PLANNING BOARD MEETING AGENDA

August 27, 2025 at 7:30 PM

- 1. PUBLIC HEARING ON THE APPLICATION SUBMITTED BY WILLOW TREE MANAGEMENT FOR ARCHITECTURAL PLAN REVIEW.** Affecting property located on the western side of Rochelle Lane, 0 feet from the intersection of East Willow Tree Road. Designated on the Town of Ramapo Tax Map as Parcel ID #41.08-1-58.1. Subject property located at 1 Rochelle Lane.

- 2. DISCUSSION ON THE APPLICATION SUBMITTED BY COOL POOL FOR RAJIV DIWAN FOR A WETLANDS PERMIT.** Affecting property located on the southeastern side of Spook Rock Road, 0 feet from the intersection of Joy Road. Designated on the Town of Ramapo Tax Map as Parcel ID#41.05-1-19. Subject property is located at 26 Spook Rock Road.
- 3. DISCUSSION ON THE APPLICATION SUBMITTED BY STANLEY MAYERFELD FOR A WETLANDS PERMIT.** Affecting property located on the western side of Wilder Road, 500 feet from the intersection of Carter Lane. Designated on the Town of Ramapo Tax Map as Parcel ID#41.06-1-70. Subject property is located at 39 Wilder Road.

PLOT PLAN FOR DIWAN
 26 SPOOK ROCK RD.
 LOCATED IN THE VILLAGE OF WESLEY HILLS ROCKLAND COUNTY, NEW YORK

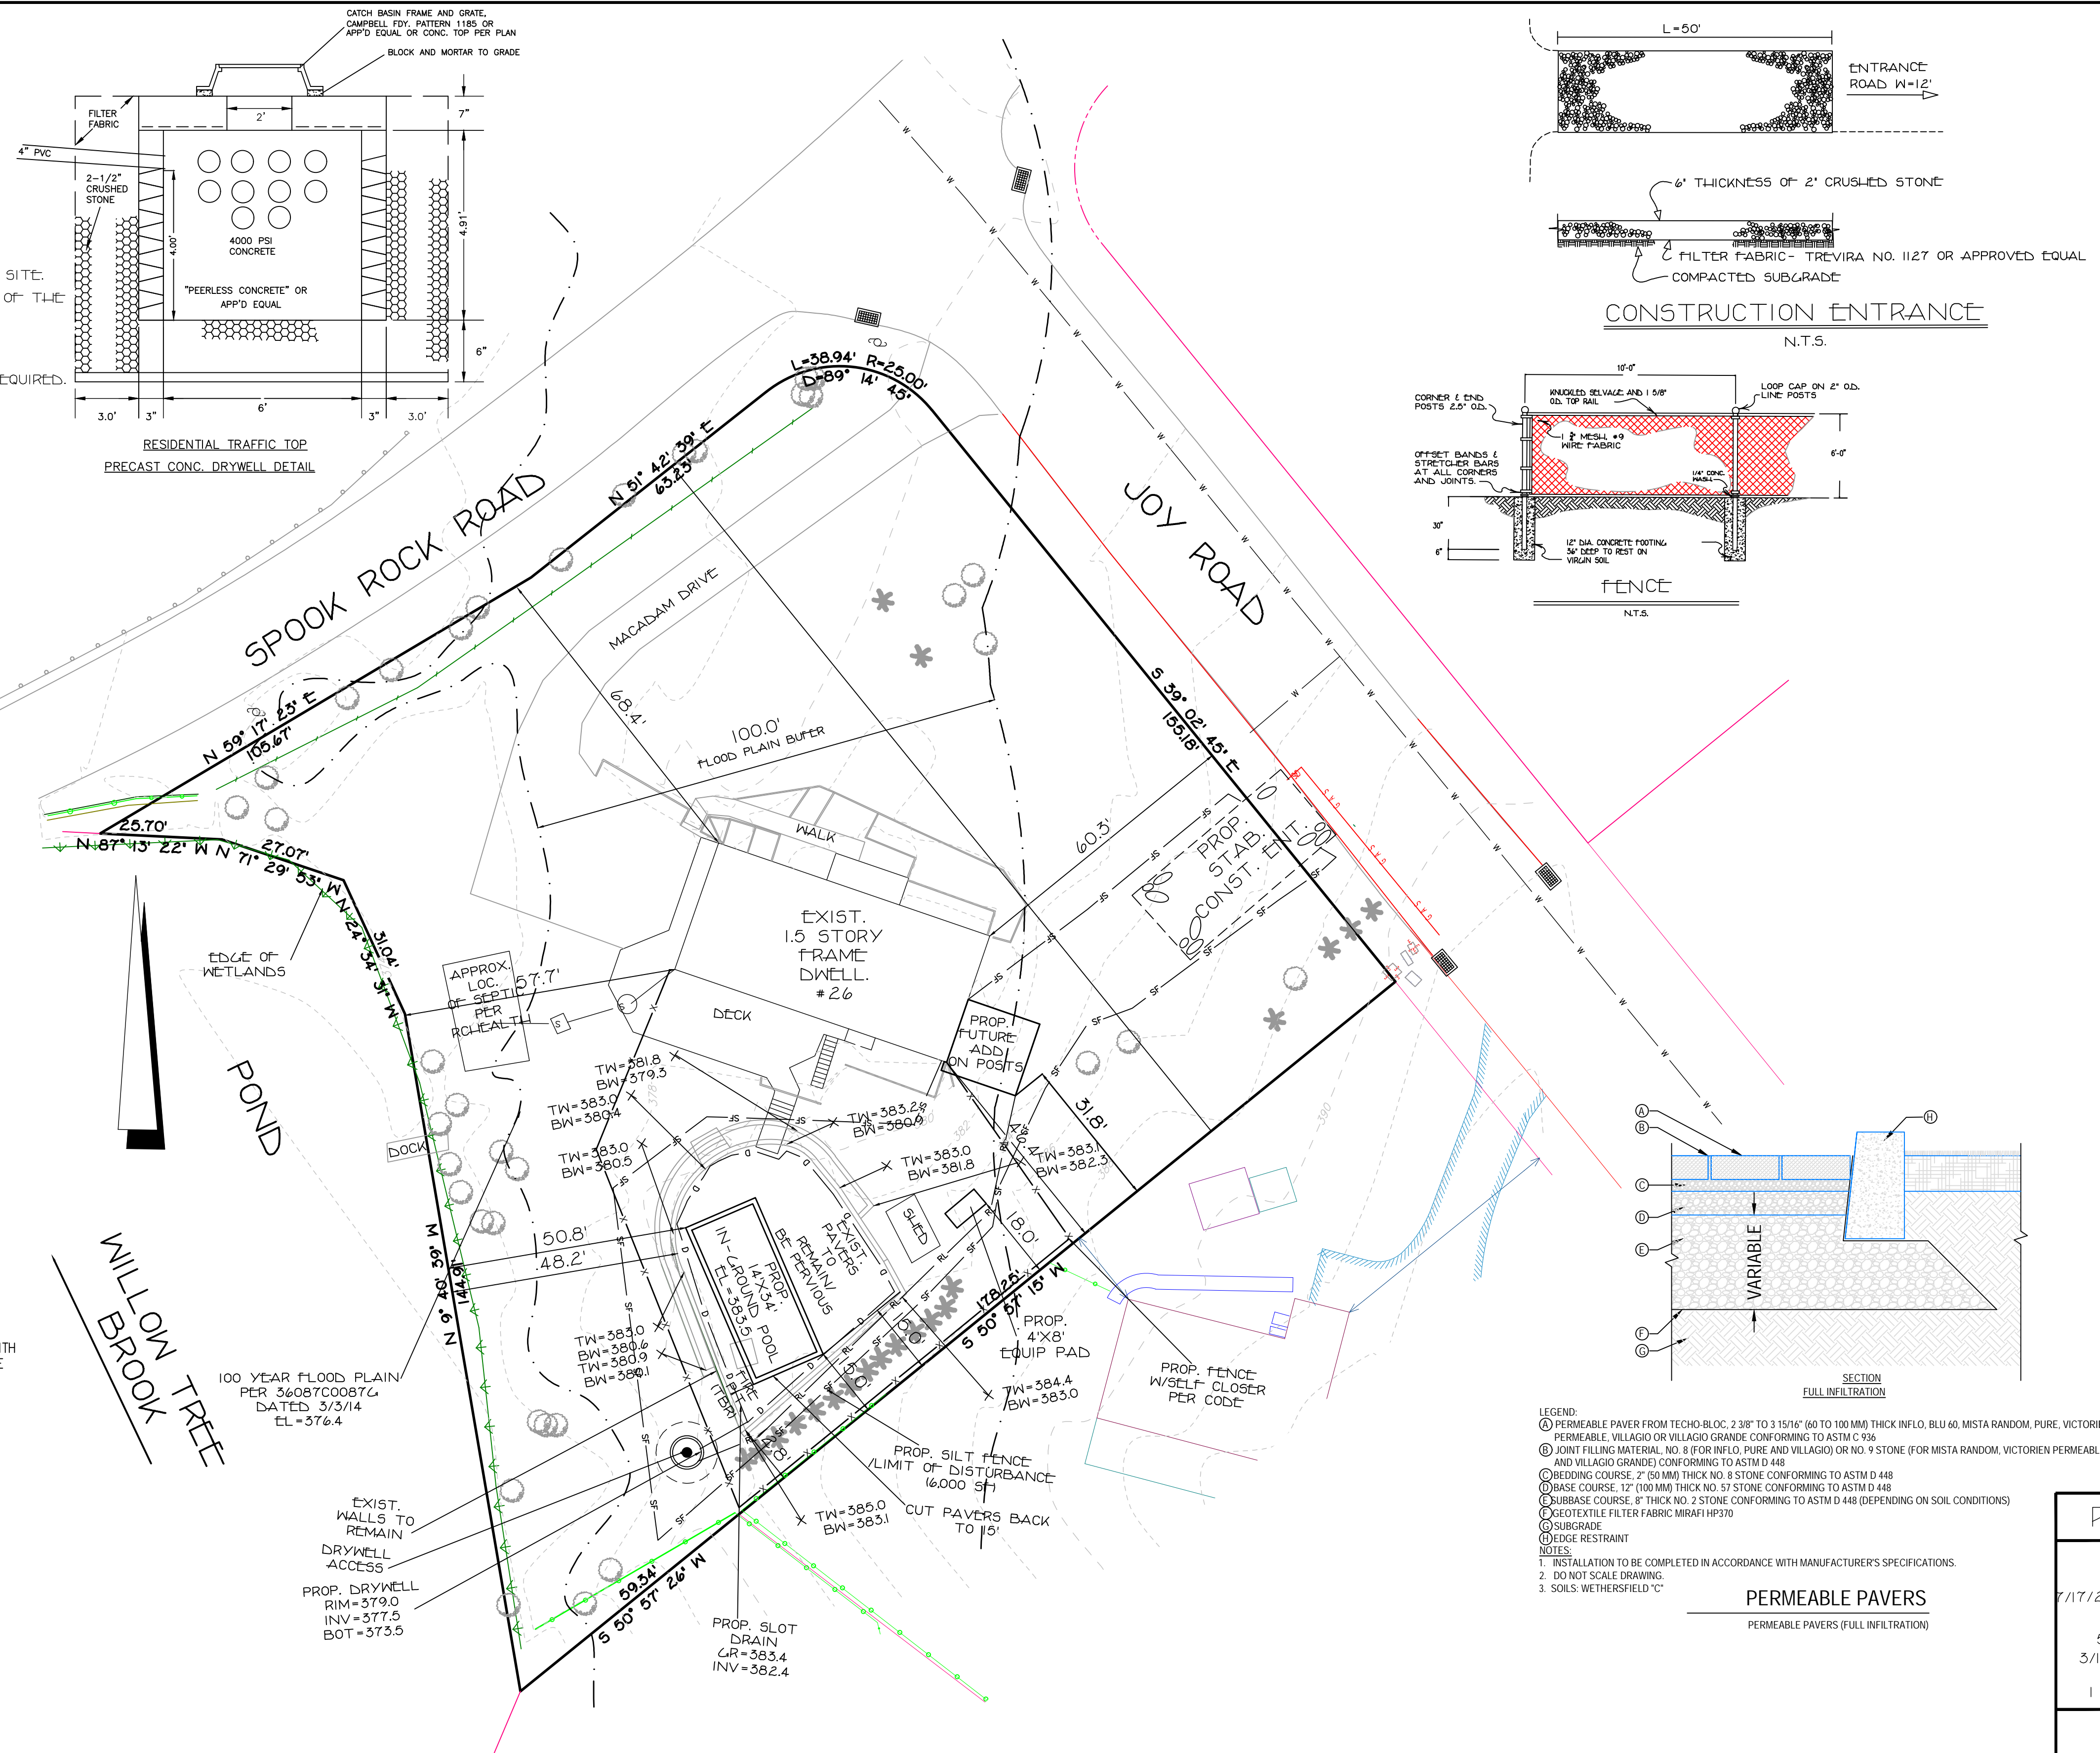
1. The wetland line is now shown on the plan. The date of the delineation and identify of the person that delineated the wetland should be added to the plan.
2. The latest revision to the plan shows a "proposed future addition on posts" on the easterly side of the existing structure. The applicant must clarify whether this addition is part of the current application. We note that the addition is reflected in the bulk table (side setback) but it is not reflected in the drainage calculations.
3. The project proposes installation of permeable pavers and a drywell. Soil testing will be required to confirm the soil infiltration rates and depth to groundwater.

4. The project proposes the construction of a retaining wall with a maximum height of less than 3 feet. A typical retaining wall detail should be added to the plan.
5. The Wetland Permit application was completed by the swimming pool contractor. The project description includes detailed information about the swimming pool equipment, but it does not include any information that describes the project in respect to the wetland.

- 1) The wetland line is now shown on the plan. The date of the delineation and identify of the person that delineated the wetland should be added to the plan.

- 2) The latest revision to the plan shows a proposed future addition on postsö on the easterly side of the existing structure. The applicant must clarify whether this addition is part of the current application. We note that the addition is reflected in the bulk table (side setback) but it is not reflected in the drainage calculations.

- 4) The project proposes the construction of a retaining wall with a maximum height of less than 3 feet. A typical retaining wall detail should be added to the plan.

It has been added to the plan.

The addition is in the drainage calculations. The applicant is planning on doing the addition in the future and rather than return again, we felt it would be best to show it now.

No retaining walls are proposed as they are all existing. A detail has been added.
